FINAL REPORT – FLOOD EVENTS AT WIVENHOE, SOMERSET AND NORTH PINE DAMS FOR FEBRUARY AND MARCH 2010

12 January 2011

- presents my final findings on a review of the operation of Wivenhoe Dam (including controlled releases) for compliance against the Flood Mitigation Manual for the period 12 December 2010 to date (Flood Event), and;
- provides advice on the prudence and appropriateness of the decisions and actions taken during the Flood Event regarding the operation of Wivenhoe Dam in light of the Flood Mitigation Manual's requirements and the circumstances of the Flood Event.

Wivenhoe & Somerset Dams – Storage Level Behaviour (as presented in Technical Situation Reports)

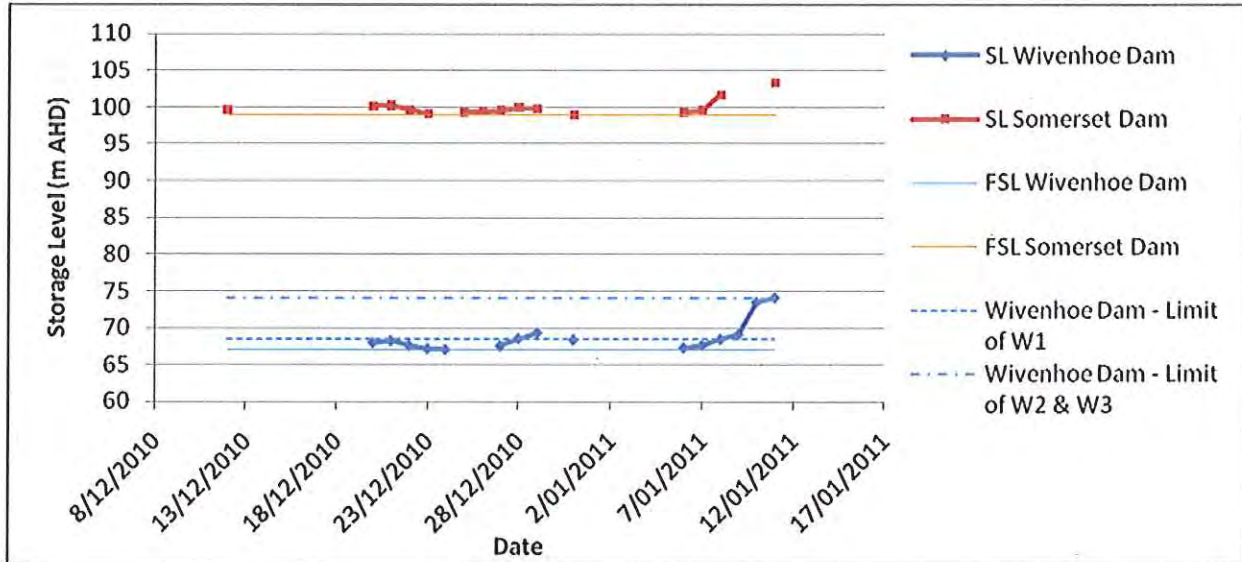
The intent of Strategy S3 (Somerset Dam Level expected to exceed EL 99.0 and Wivenhoe Dam level expected to exceed EL 75.5 (fuse plug initiation) during the course of the Flood Event) is to maximise the benefits of the flood storage capabilities of the dam while protecting the structural safety of both dams.	Not relevant at this stage
The safety of Somerset Dam is the primary consideration and cannot be compromised and its peak level cannot exceed EL 109.7.	Maximum level only EL103.3
